MADRAS RECORD OFFICE.

*Proceedings of the Madras Government, Public Works Department,
25th February 1873*

MEMORANDUM ON VIZAGAPATAM HARBOUR.

No 555A REPORT TO ACCOMPANY ESTIMATES FOR IMPROVING THE MOUTH
OF THE VIZAGAPATAM RIVER

Cross section
of sand bank at
the mouth of the
Niagara Falls
river, on the
left side.

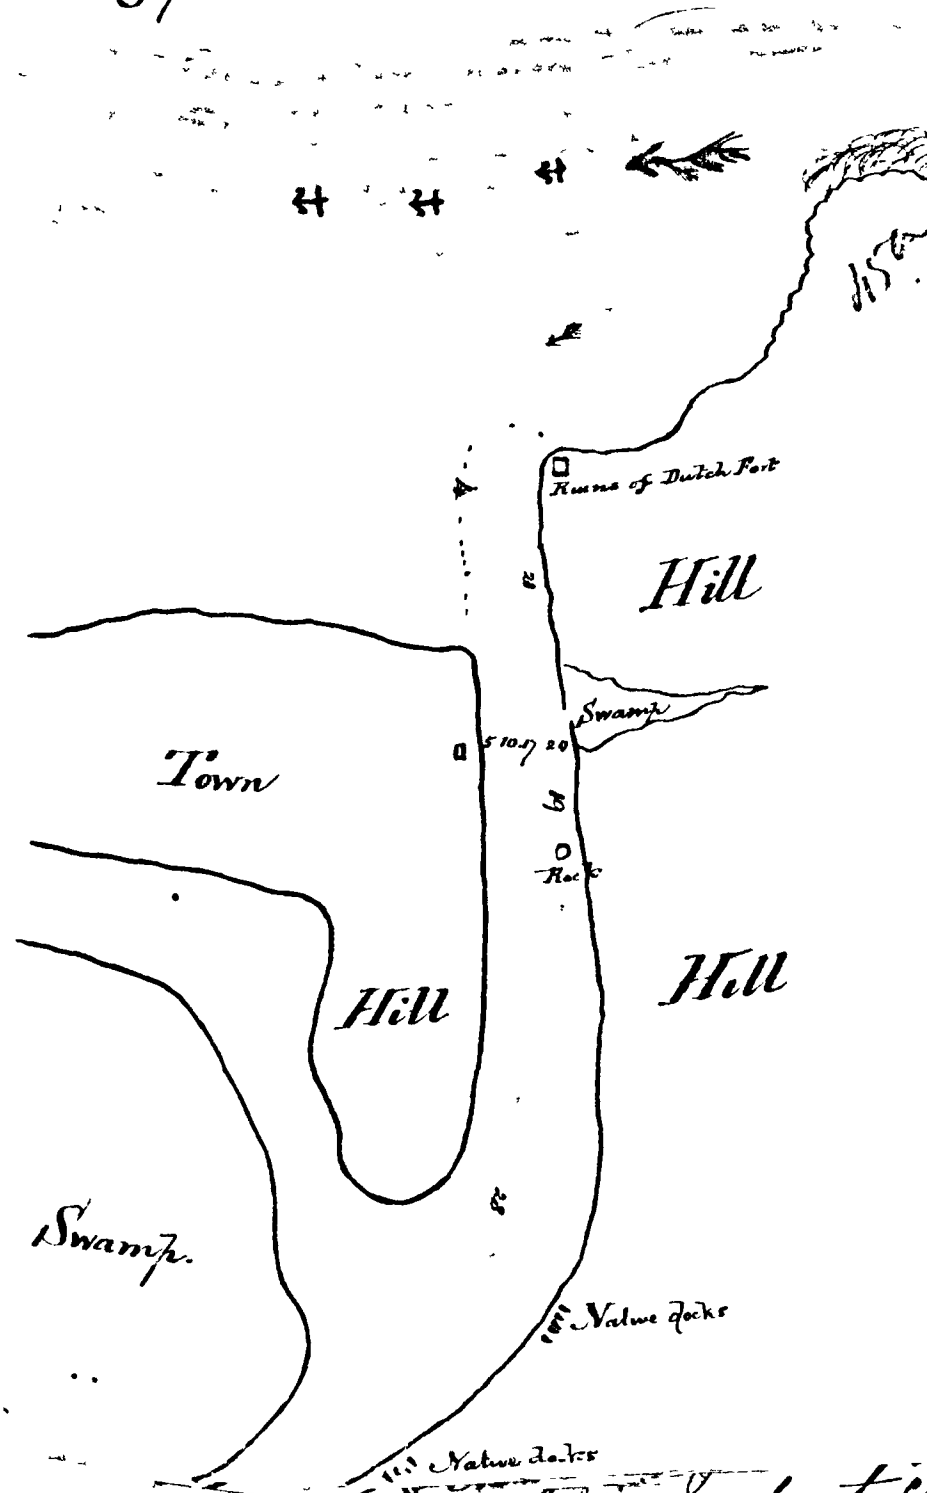
sections accompanying Major Beatty's report are inexact as to plan, and inconsistent as to soundings. Mr Thomas remarks that in planning harbour works much more is dependent on knowledge of local natural circumstances than on the very best professional talent that can be devoted to it. It would be more correct to say that no professional opinion can possibly be formed without a precise knowledge of local natural circumstances; and that when these are known real professional knowledge is shown by drawing correct conclusions from them.
